## SERVICE BULLETIN

**Bulletin No. 02-09**  
**March 31, 2009**

**Subject: Fluid Nozzle O-Ring on Vector Coded Guns**

**Figure 1 Vector Coded R90/R70 O-RING REMOVED DIAGRAM**

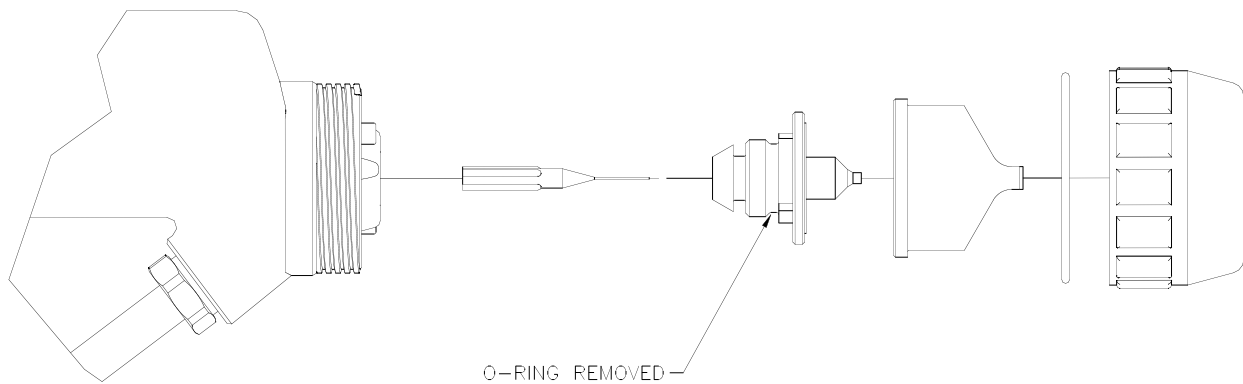
The o-ring on the fluid nozzle (p/n 79377-xx or 79552-xx) is no longer required. Any future shipments of Vector coded applicators models 79500, 79503, 79504, 79520 and 79523 will not have the o-ring shipped installed. The function of this o-ring was to allow a true round pattern when the fan air valve was completely closed. For those applications that require the true round pattern, the o-ring should be added.

If you have an older Vector coded low-pressure model, when you perform maintenance on the product, the o-ring should be removed. Insure that when the nozzle is re-installed it is properly torque in place.
